CITY OF DOVER

PLANNING TECHNICAL REVIEW COMMITTEE –AGENDA

TECHNICAL REVIEW COMMITTEE MINUTES – P19-07

Below please find our responses to the January 31, 2018 Technical Review Committee Minutes as to how our plans have been revised to address these comments.

BUFFER WAIVER PLAN

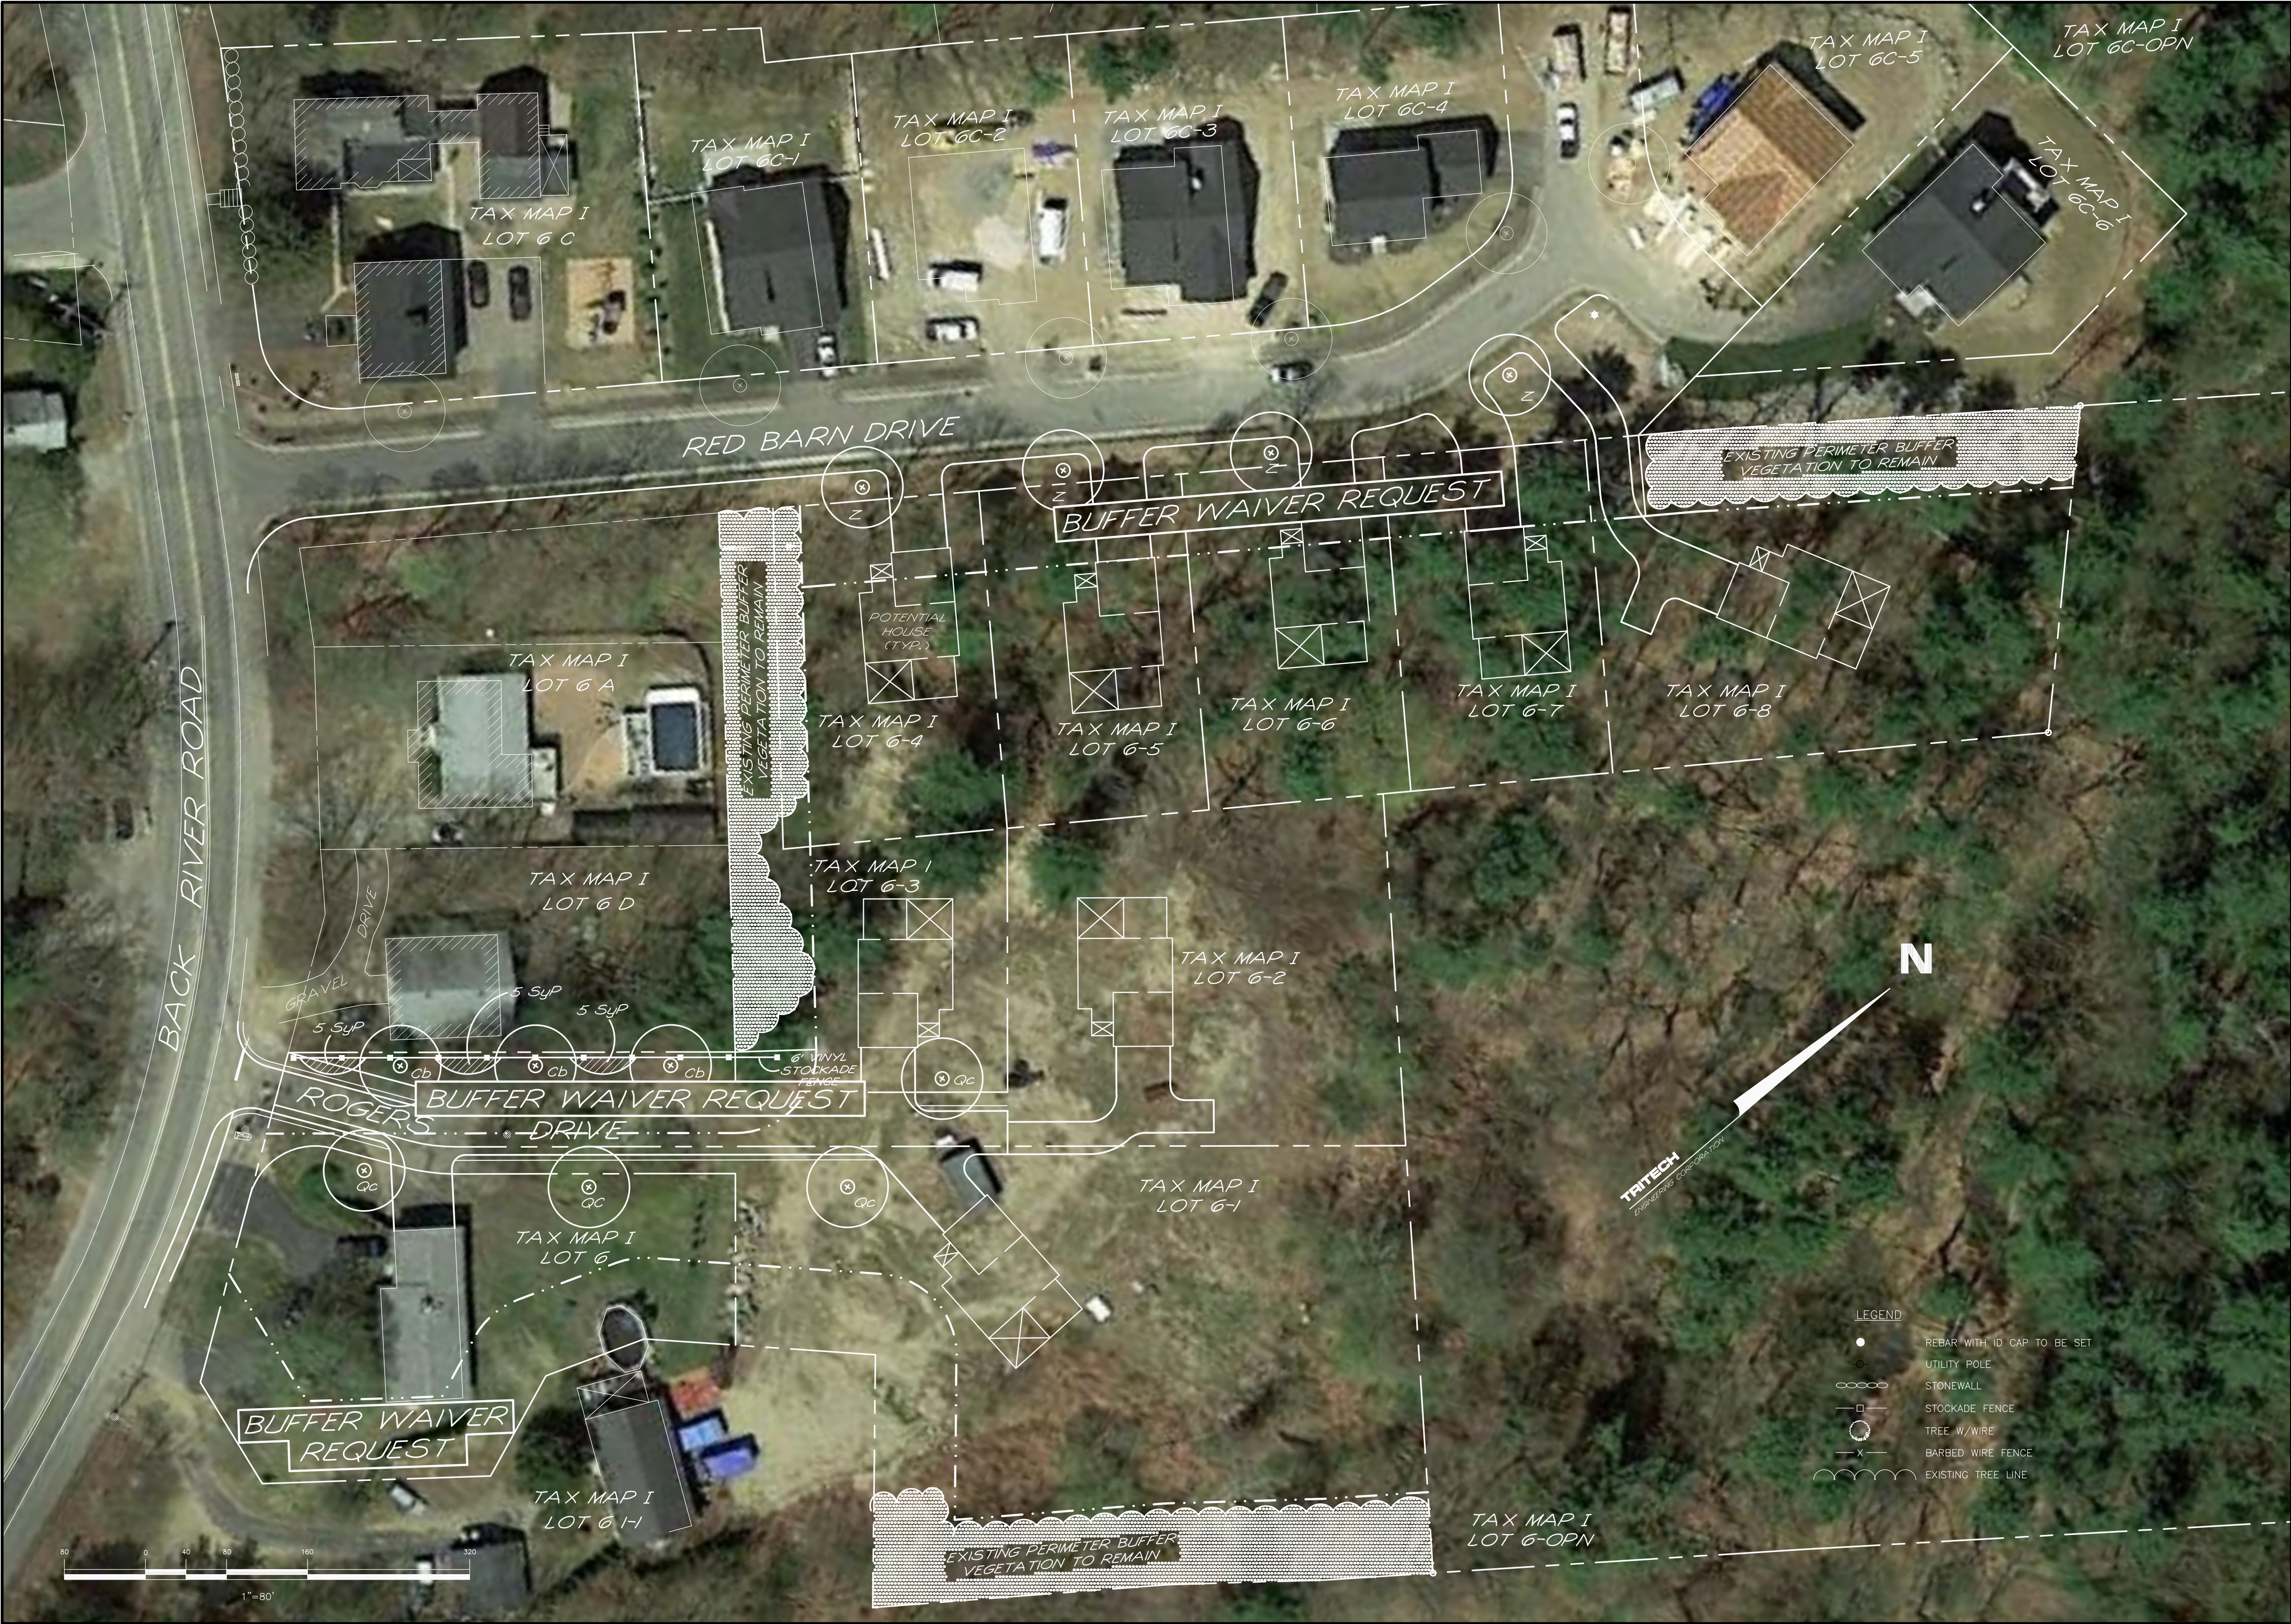
- Indicate property line information to tie into Dover GIS
-Note 12 on Sheet S-1 indicated that the project is based on Dover GIS.
 - Show 30' buffer along Red Barn Drive
-See attached waiver request.

1. Chapter 155-22.F(4), establishes the minimum distance from external boundaries to dwellings within the open space subdivision under consideration by the board. In addition, with respect to that established distance the ordinance states; “whenever possible the natural vegetation shall be retained, or if required, vegetation shall be planted of sufficient size to shield the development from abutting properties”. In the R-12 District this established distance is 30 feet.

2. Chapter 155-51.A(2), allows the board to grant a waiver if; “specific circumstances relative to the subdivision, or conditions of the land in such subdivision, indicate that the waiver will properly carry out the spirit and intent of the regulation”.

S-1

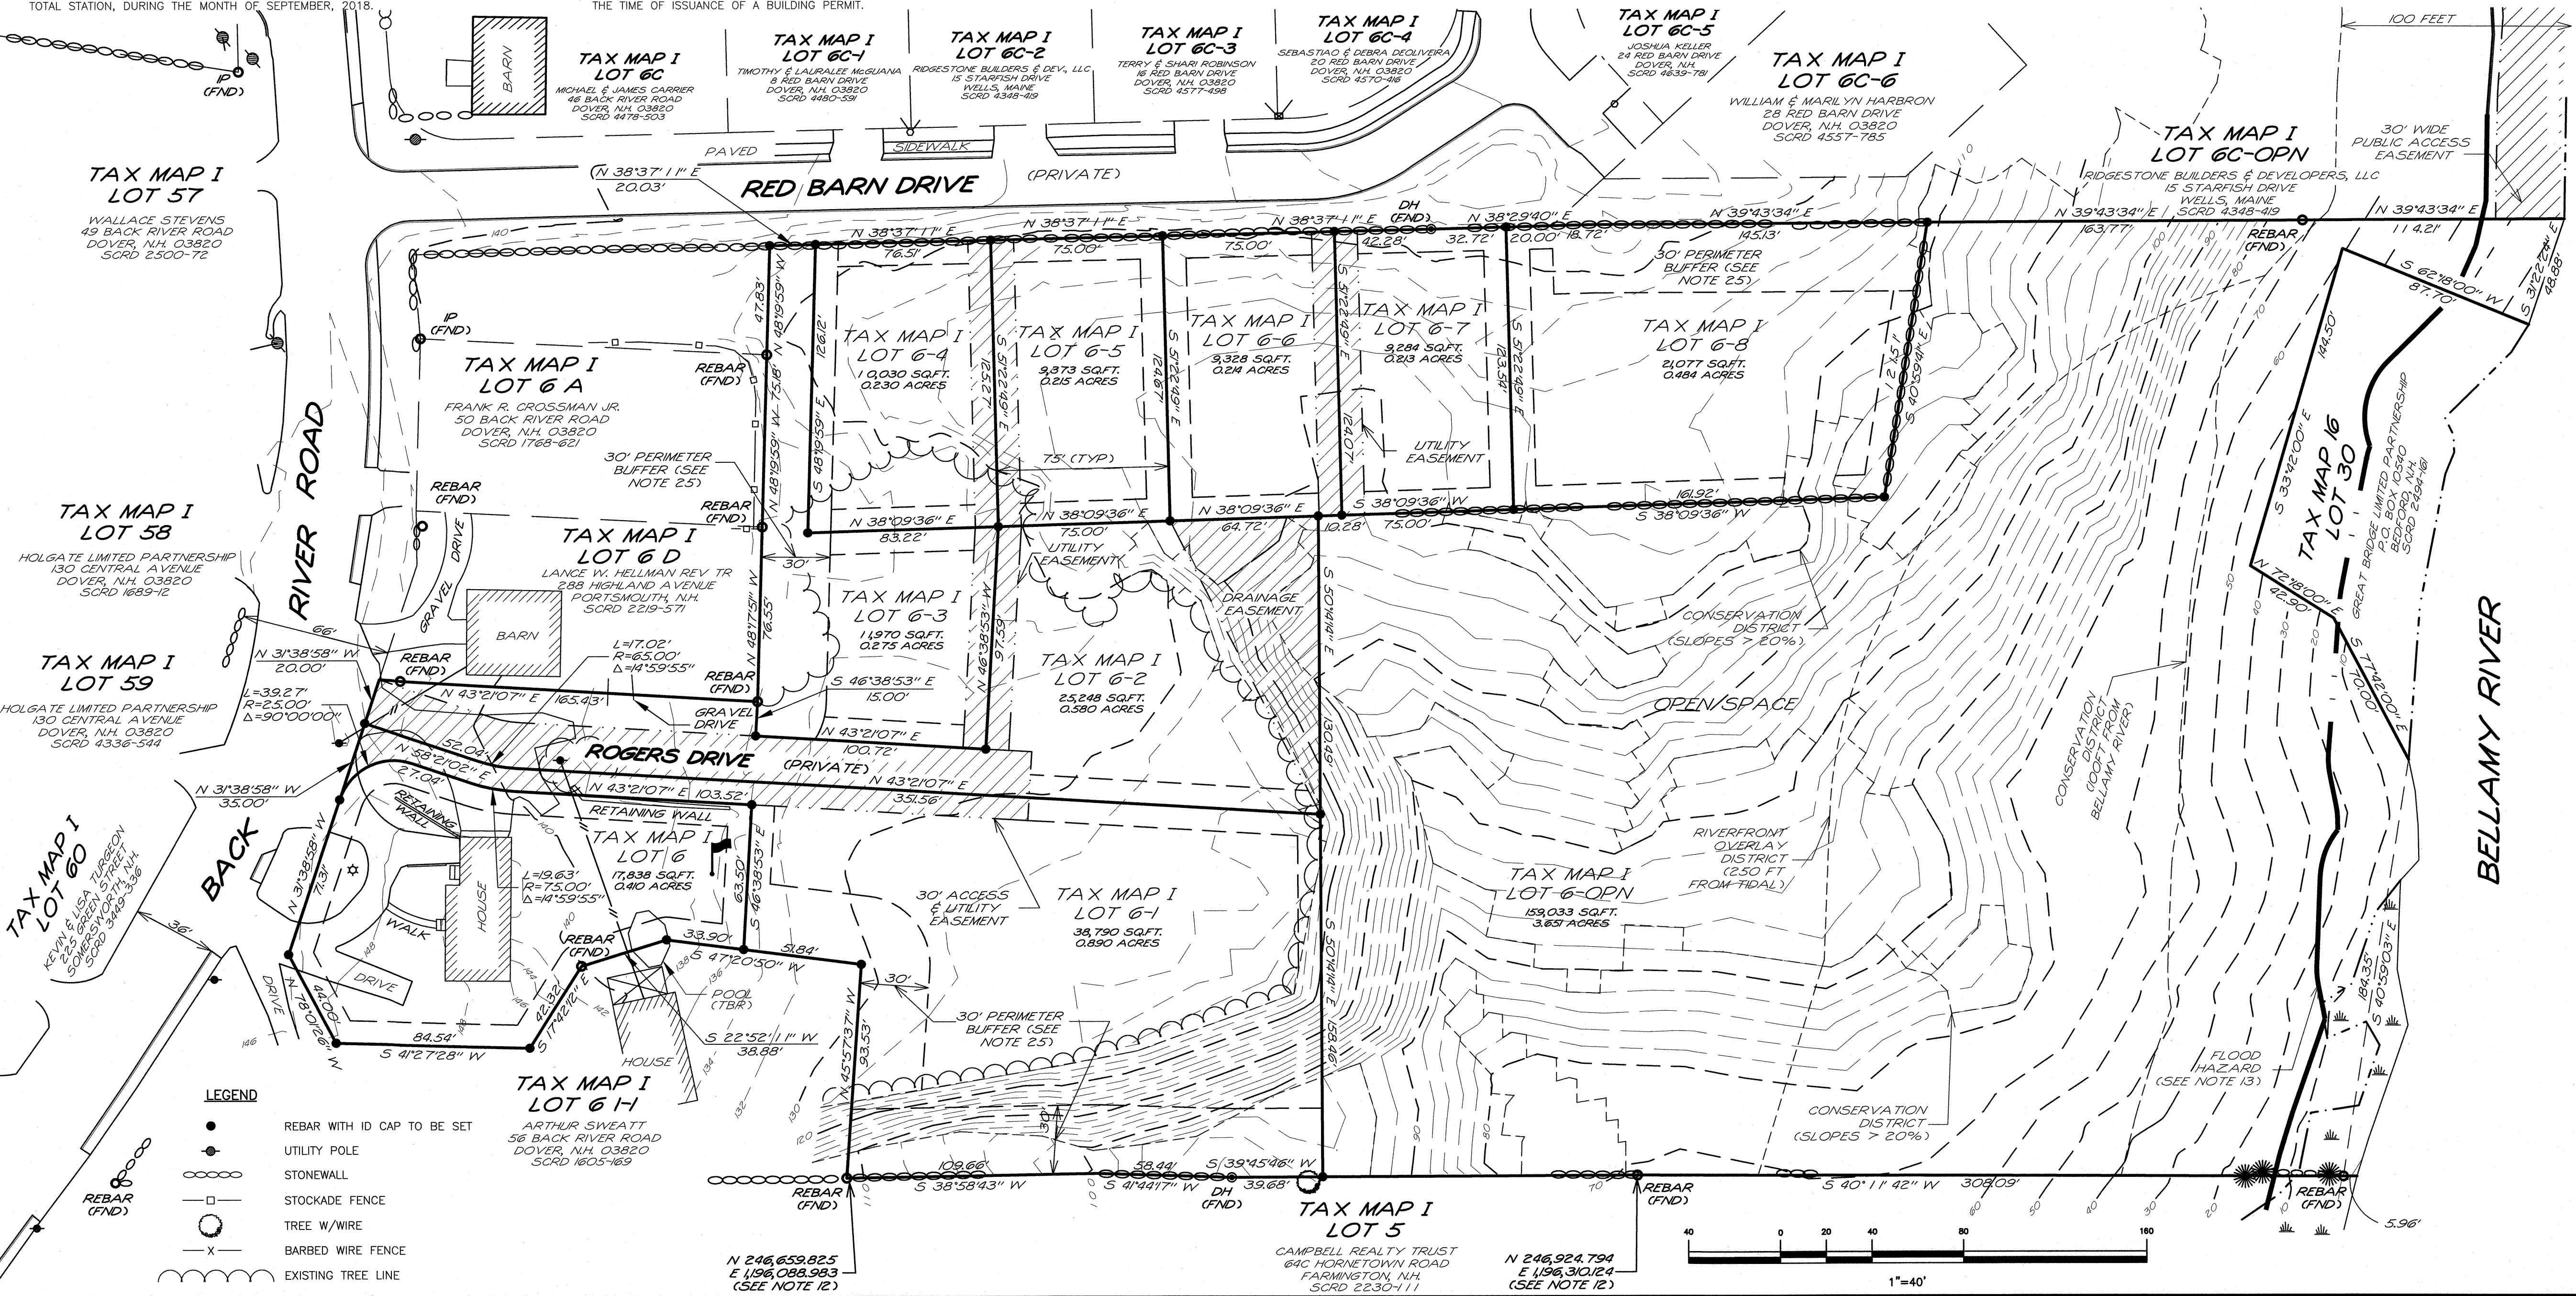
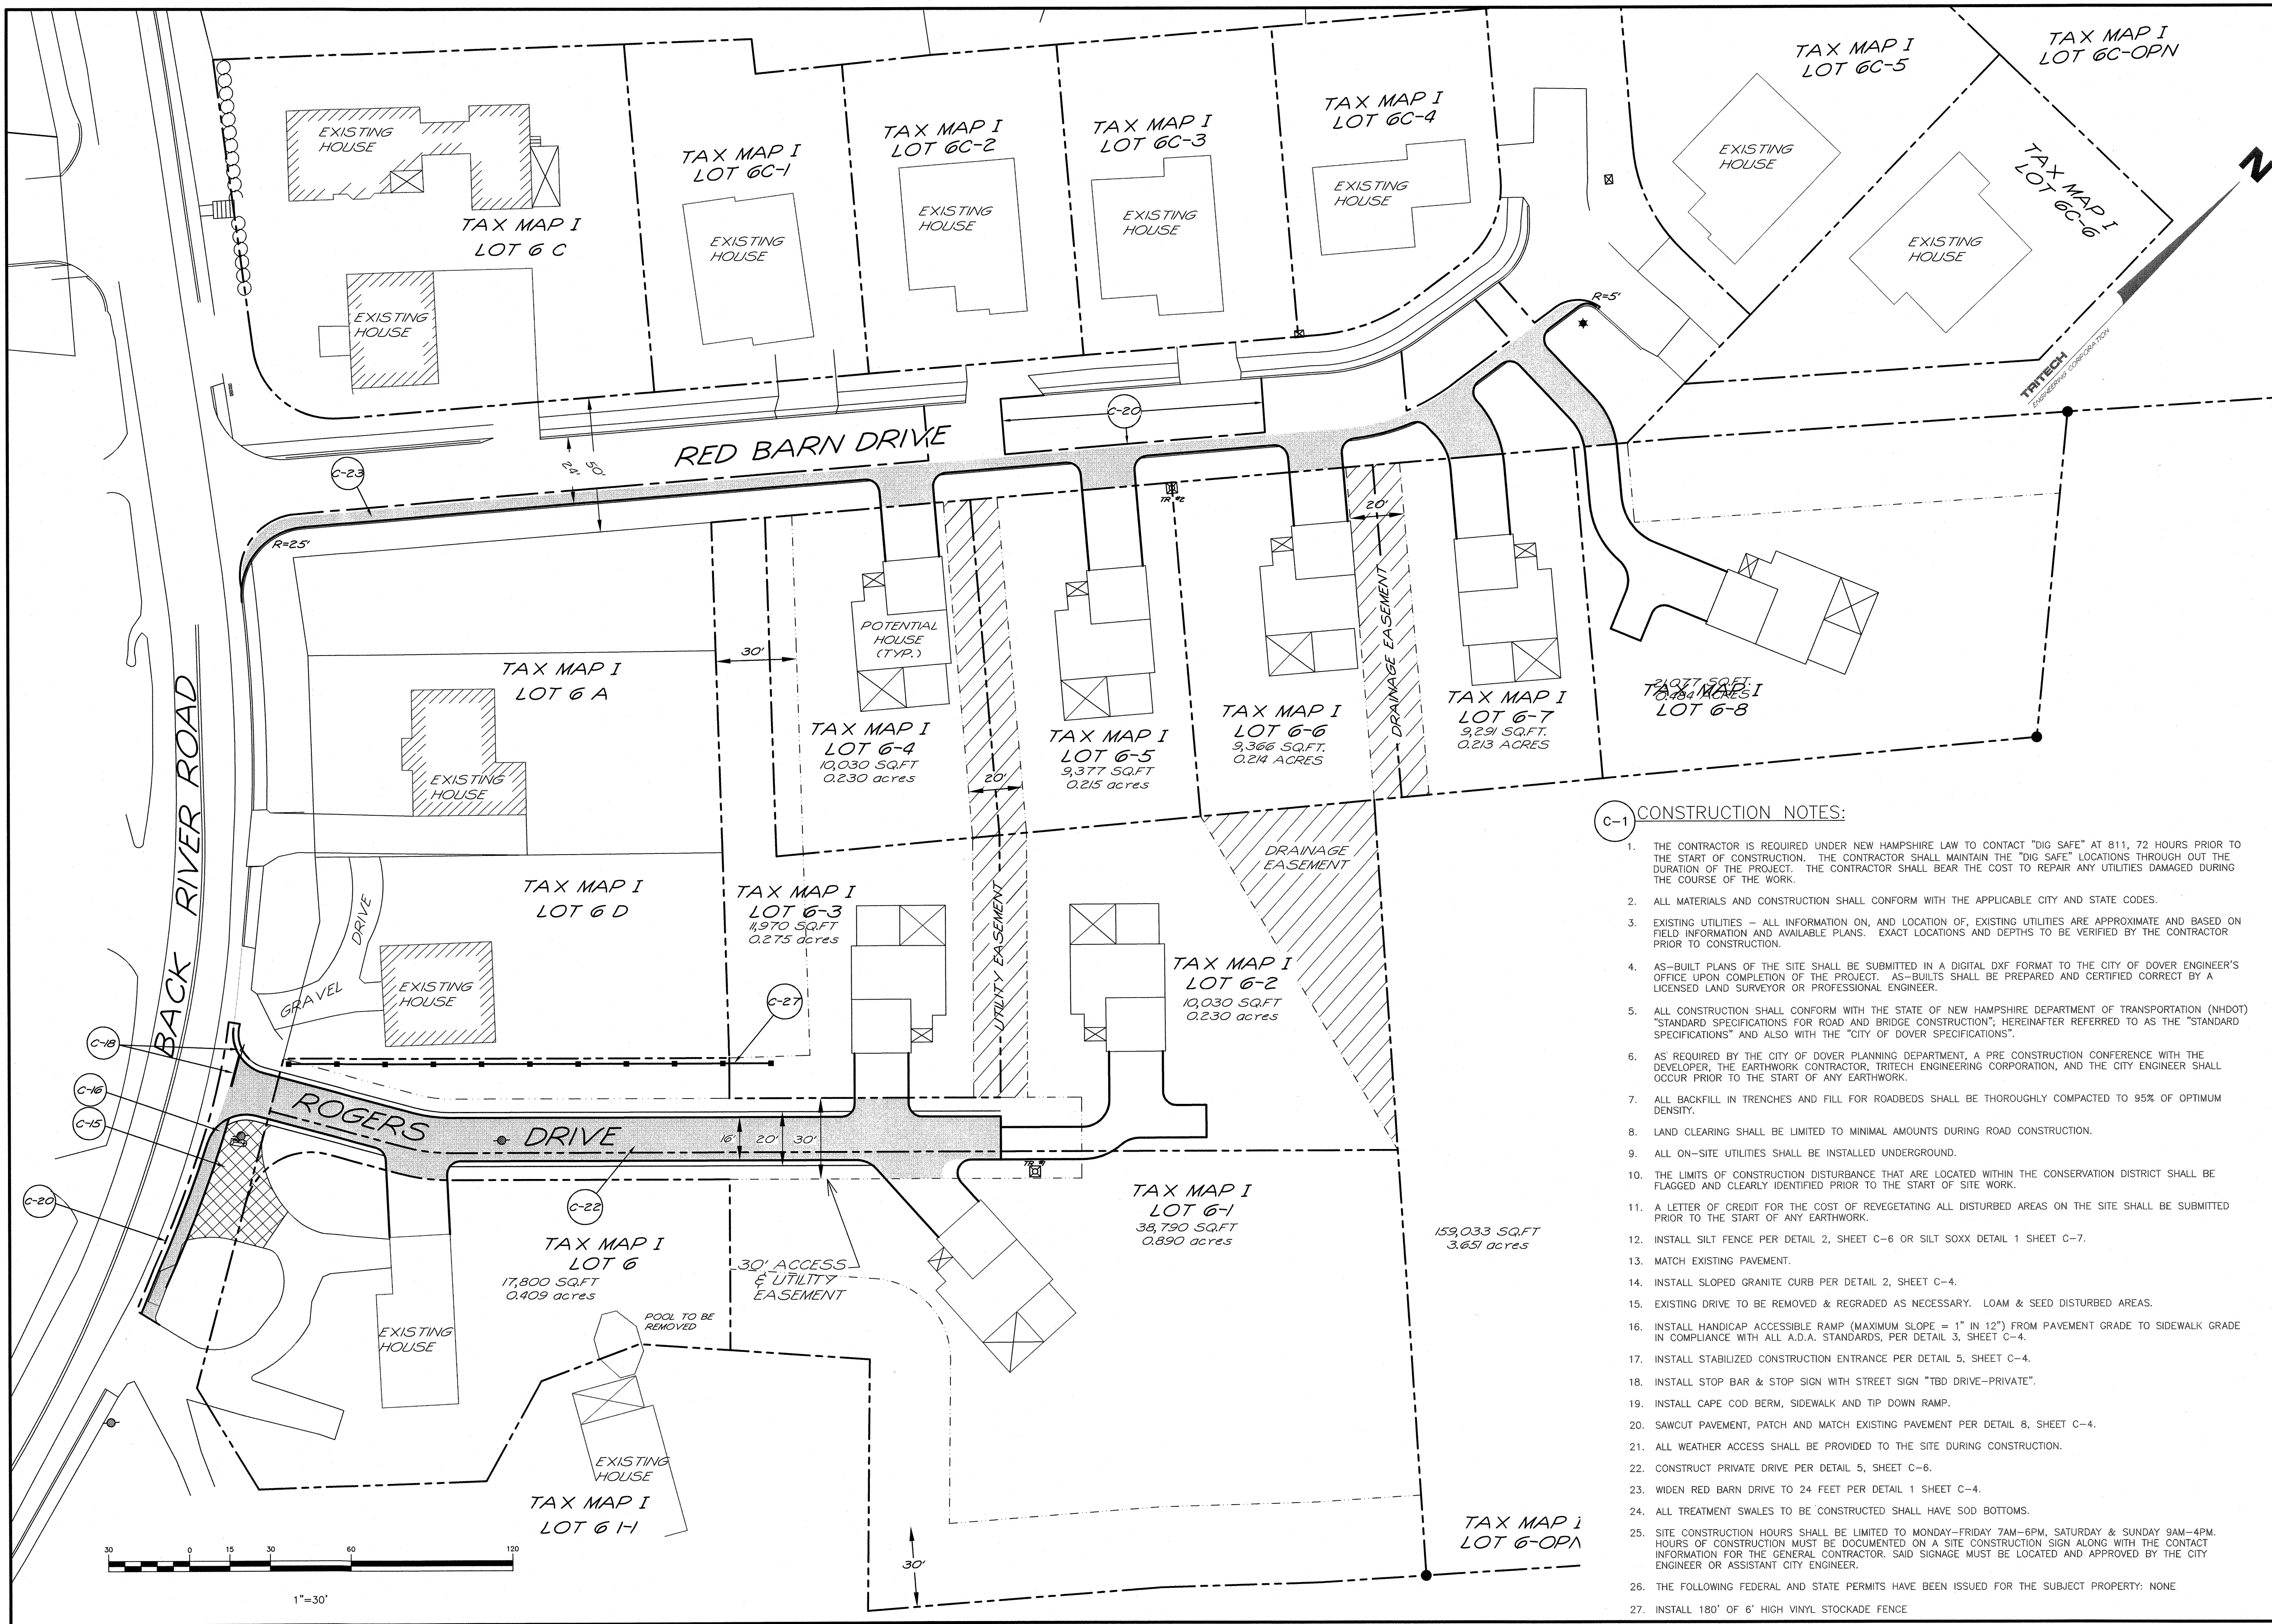
- Revise app to indicate single family instead of duplex
-Note 19 on Sheet S-1 is accurate.
- Water and Sewer Investment Fees
-The applicant understands this requirement.

- Plan S-1 note 19 indicates the site is for SFD however application appears to be for 6 sfd and 2 duplexes.
-Note 19 on Sheet S-1 is accurate.
- Clarify the width of the structural roadway
-Detail 5, Sheet C-6 shows 20 feet of all-weather access.
